OMAouter definition ambiguity

Addressing comments #171, 172, 173, 181 against IEEE 802.3 dj draft 2.1

Laurent Alloin, Amitkumar Mahadevan, Karen Liu
Nubis Communications

121.8.5.3 TDECQ measurement method

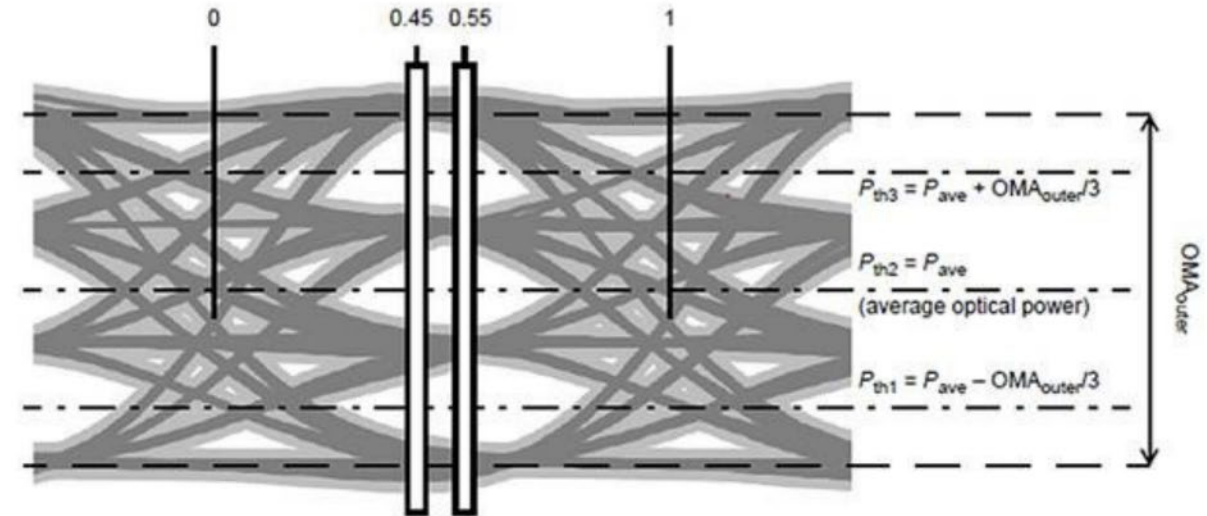
OMA_{outer} is measured according to 121.8.4 on the equalized signal.

This sentence should have been “on the unequalized signal”

Figure 180–5—Transmitter $\text{OMA}_{\text{outer}}$ each lane versus $\max(\text{TECQ}, \text{TDECQ})$ and receiver sensitivity ($\text{OMA}_{\text{outer}}$) each lane versus TECQ

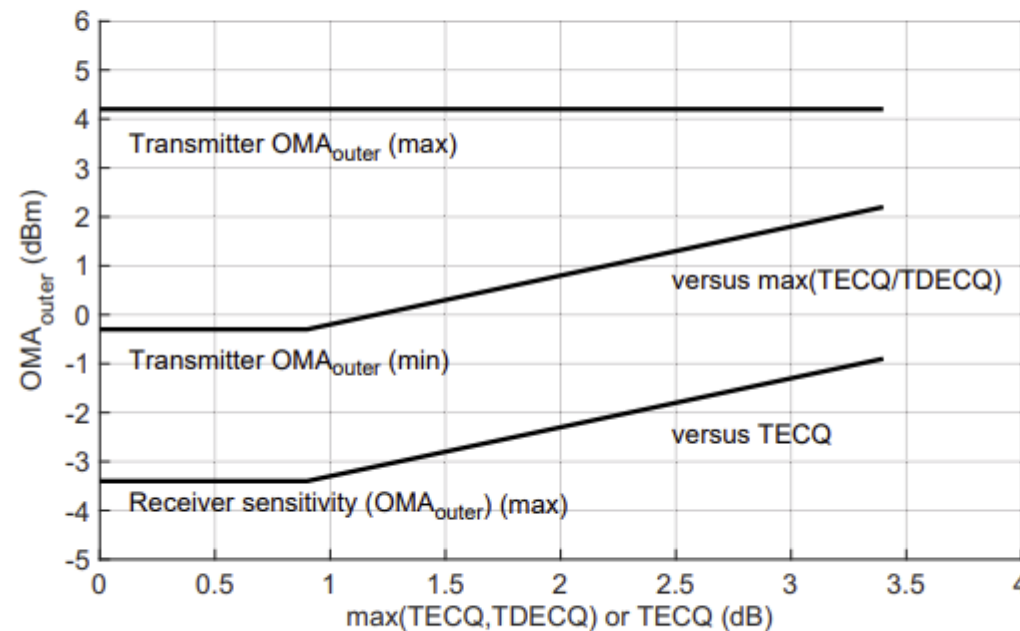
For Link budget calculation, it is ambiguous whether the $\text{OMA}_{\text{outer}}$ considered is measured “before the reference equalizer” or “on the equalized signal”

Since $\text{OMA}_{\text{outer}}$ -TDECQ is understood as the “usable” OMA of the TX as seen by the reference RX, both quantities need to be defined consistently.

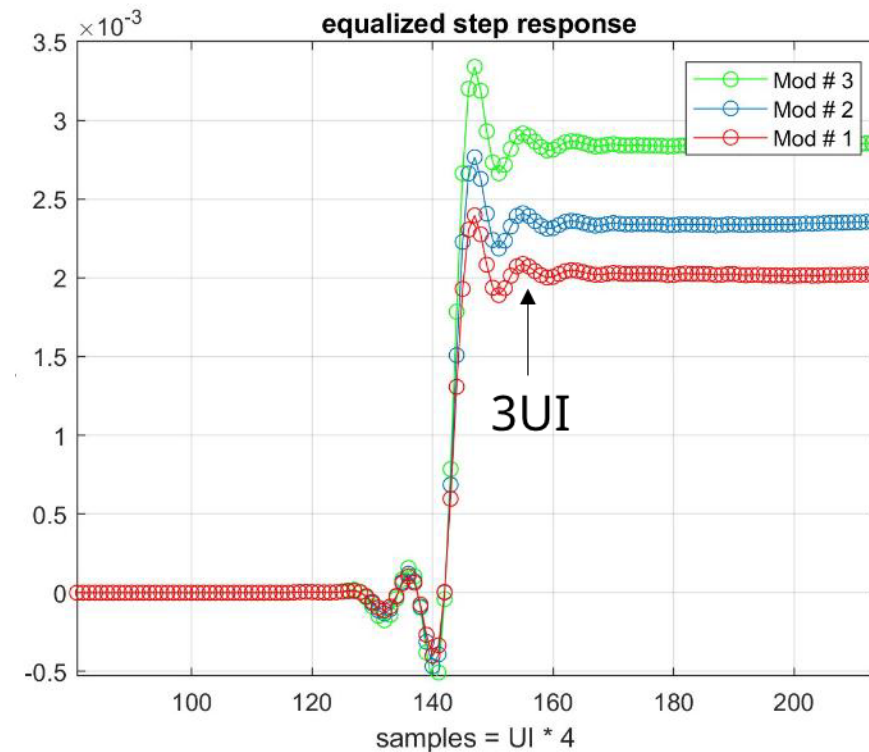
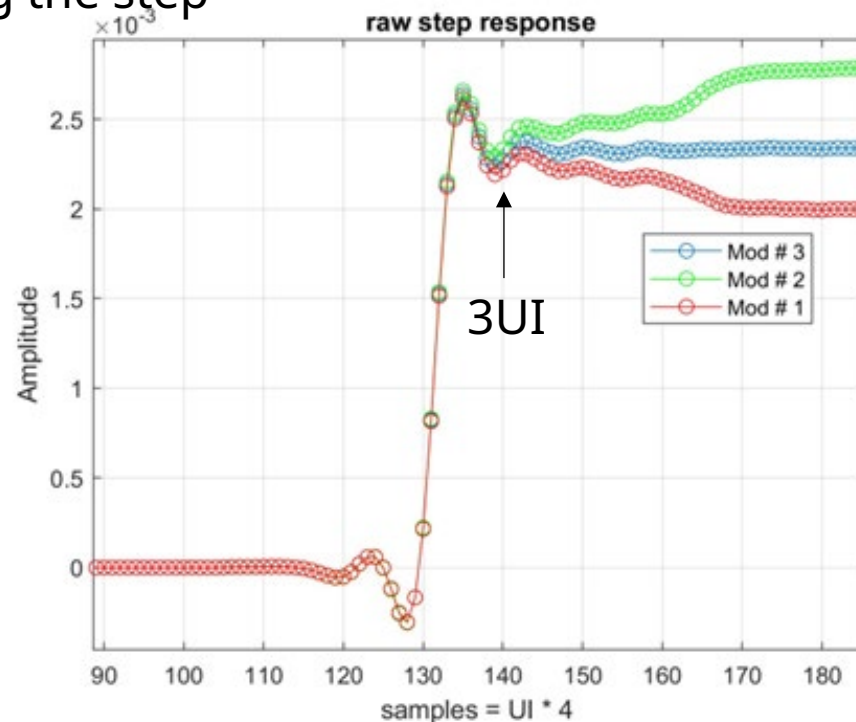
Un-equalized channel responses show similarity within 3 UI of step.

Equalized response shows already significant amplitude difference within the 3rd UI following the step

Note: 2 and 3 UI after step is what is used for OMAouter measurement, with runs of 7 threes and 6 zeros

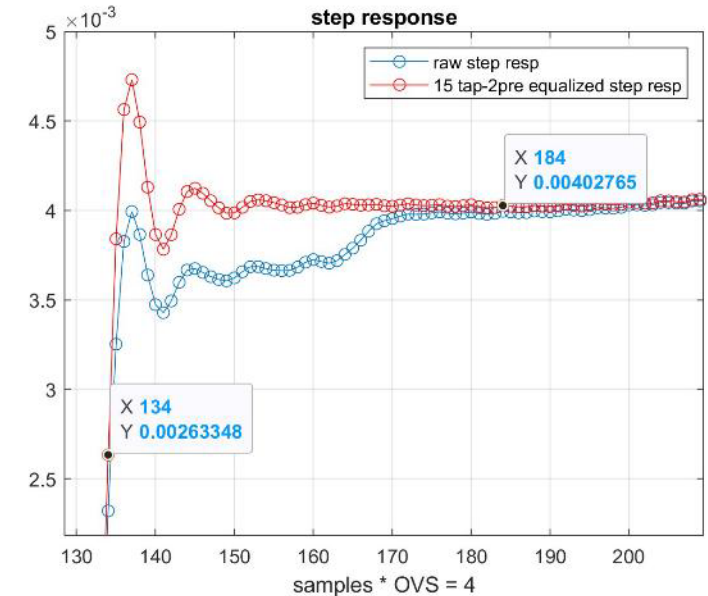
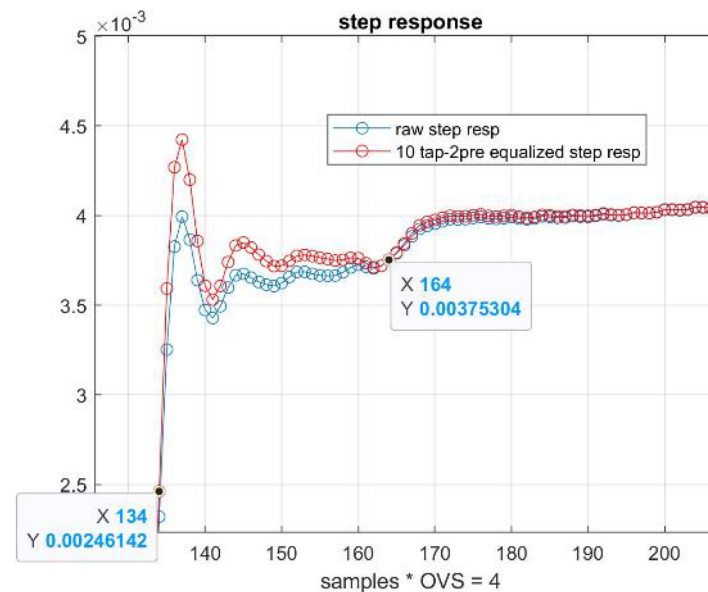
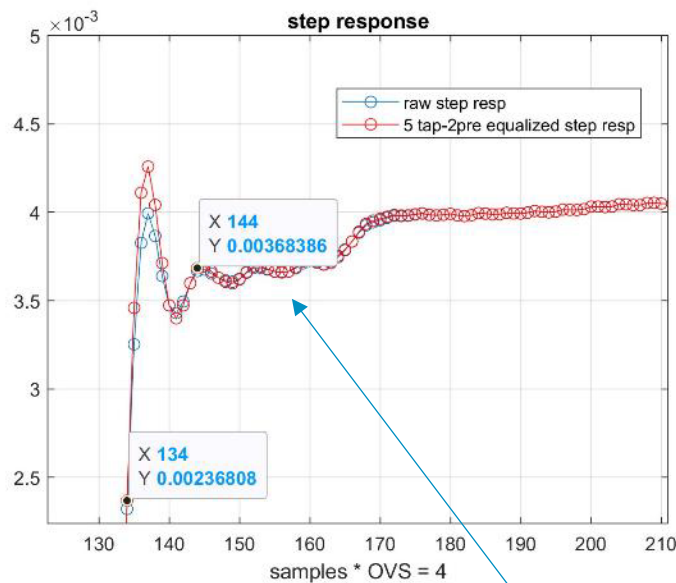
A discrepancy of equalized and un-equalized channel responses comes from the inconsistency between the OMA pattern length and the number of taps of reference equalizer.

It gets worse with the increase of taps of reference equalizer

Here, step responses differ following an increase of number of post-cursors:

Use of prior 400GBASE-DR4 5 taps reference equalizer was consistent with measurement of raw waveform as currently defined in IEEE.

Possible reconciliations

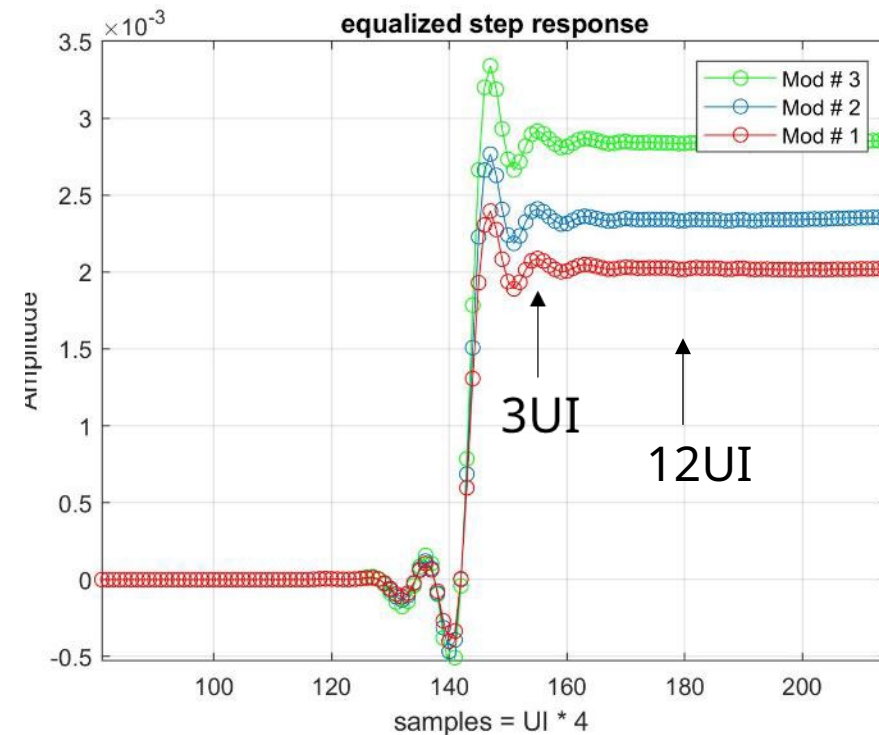
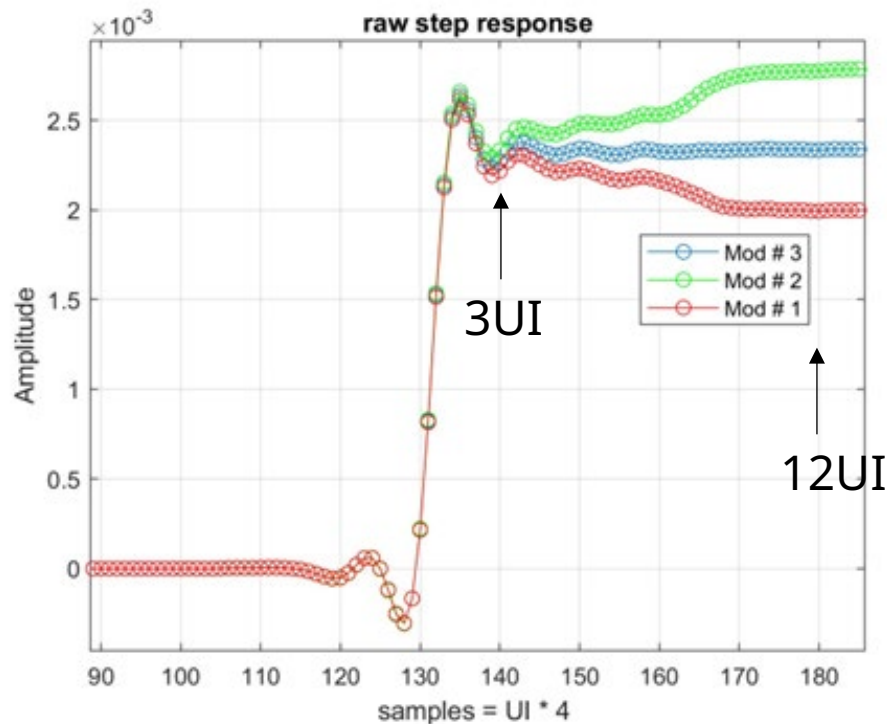
- A. Perform OMAouter measurement 12 UI after step on un-equalized signal in sequence of length 15. Problem: PRBS13Q has length of 0s/1s of duration 6/7 only – SSPRQ has length of 0s/1s of duration 14 only
- B. Use OMAouter measured on the unequalized signal in TDECQ metric computation (formula 121-12).

Effect of DFE tap

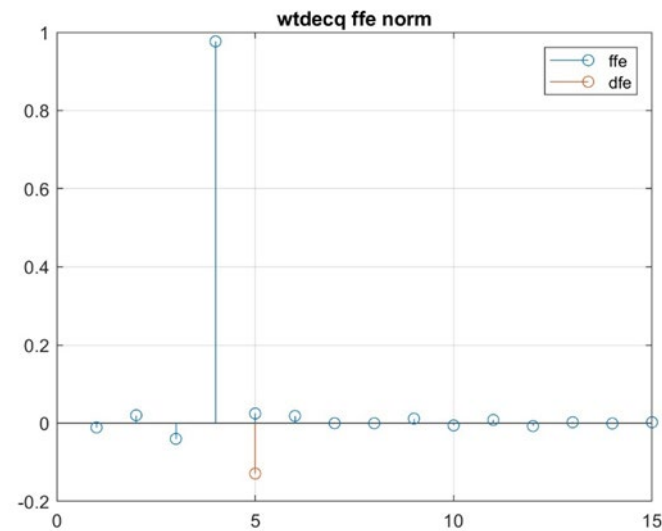
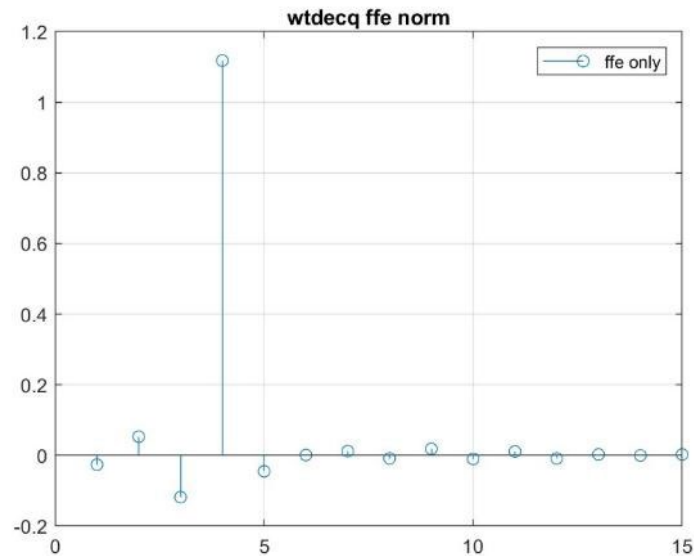
With inclusion of DFE in reference Rx equalizer, OMAouter used in TDECQ is altered after normalization of FFE to unity => TDECQ penalty therefore also needs adjustment to be in line with OMAouter for link budget computation, when using a DFE
